SERVICE LETTER

No. 718

Subject:

Bendix Magneto Bulletin No. 566 -- reference attached Avco Lycoming Service Bulletin No. 373, dated March 22, 1974.

Figure 1.

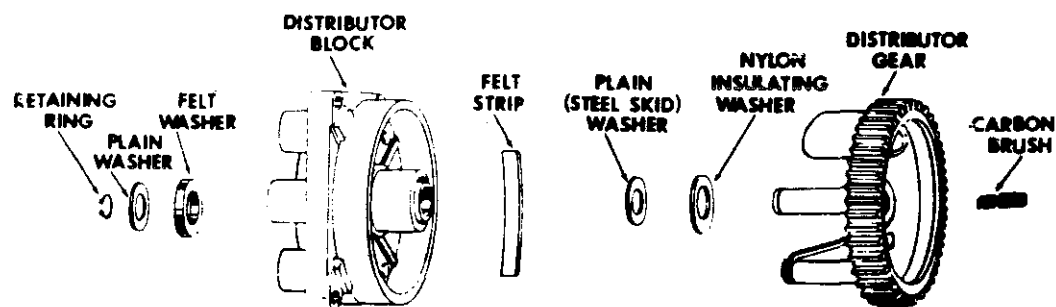
It has been found that the addition of a nylon insulating washer and steel skid washer between the distributor gear electrode and the block bushing, as shown in figure 1, reduces the possibility of deterioration of the lubricant and possible seizure of the parts.

Once modified, the distributor block can be used only with a gear having the nylon and steel washer installed over the shaft as shown in figure 1.

Assemble large distributor gear, nylon and steel washers to new or reworked block as follows using figure 1 as a guide.

2. Slide nylon insulating washer 10-391309 and plain washer 10-391511 onto gear shaft.

3. Lubricate inside of bronze bushing with a light film of Bendix Distributor Block Lubricant. ** Insert shaft of gear through distributor block and position plain washer on shaft. Using the 11-3071 Retaining Ring Pliers, install retaining ring on shaft. Rotate gear to insure there is no interference between gear electrode and block electrodes.

Figure 2

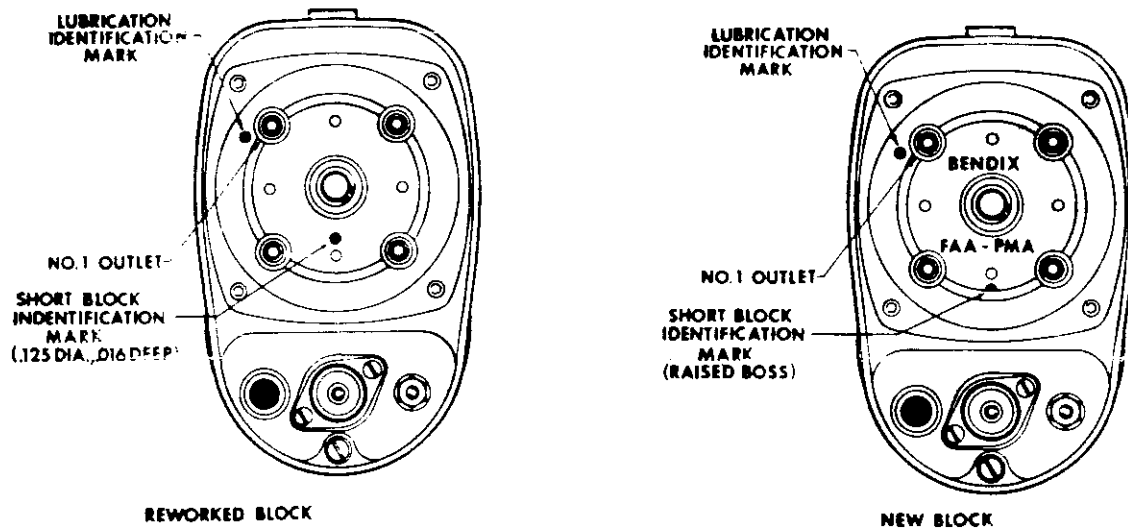
The addition of the washers make it necessary to shorten the gear end of the bushing and block. New production blocks incorporating the change are identified by a raised

boss between the high tension towers at the six o'clock position and molded in letters as shown in figure 2. Reworked blocks are identified by a drill point indentation in the same location. New and reworked blocks both have different part numbers from the current (old) block. See Table 1.

7. Identify reworked blocks by drilling a flat bottomed hole .125" diameter and .016" deep in the six o'clock position as shown in figure 2.

(3) Identify distributor block by drilling flat bottomed indentation 0.125 inch diameter and 0.016 inch deep located as shown in figure 2.

Figure 3.

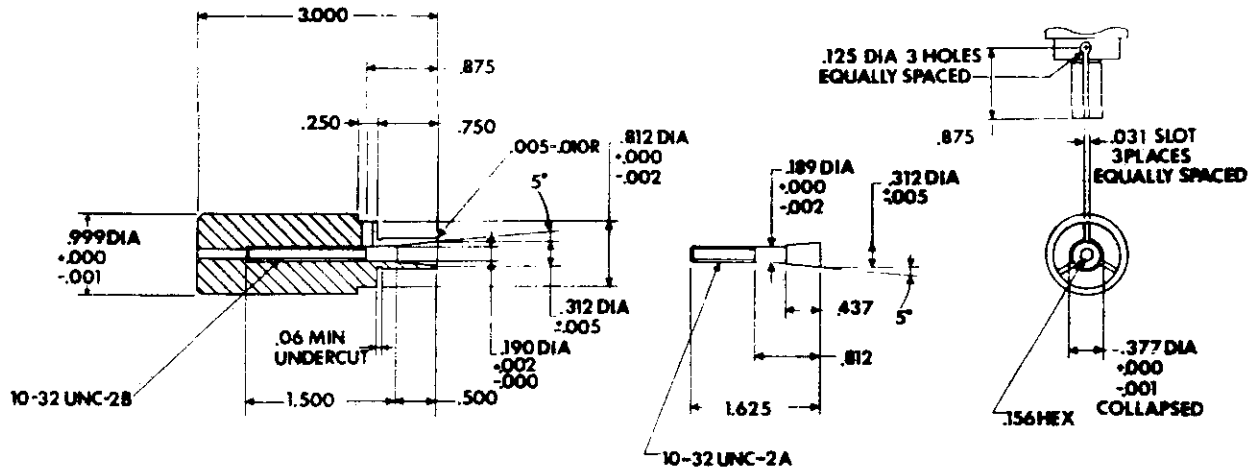
2. Fabricate an expanding arbor lathe fixture as shown in figure 3. (Similar arbors may be purchased from industry machine tool supply houses.)

3. With arbor in lathe, slide distributor block over arbor, high tension outlet tower side first, until block bushing bottoms on arbor shoulder. Tighten arbor expansion screw until block is held securely for turning operation.

Figure 4.

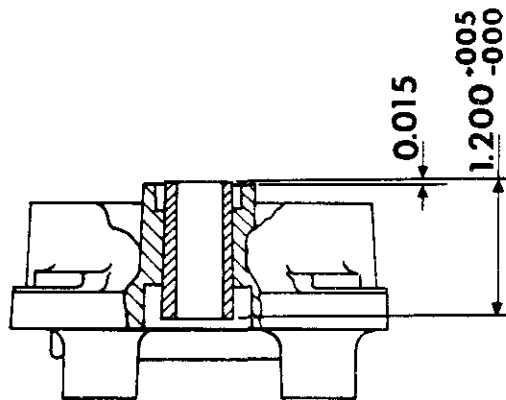
4. Use a suitable cutting tool and turn so that overall length of bushing is $1.200 + .005 - .000$ inch as shown in figure 4. (A Carbide tipped tool is recommended.)

5. Using same cutting tool, turn dielectric material of block so that resulting surface is .015 inch below end

of reworked bushing. See figure 4.
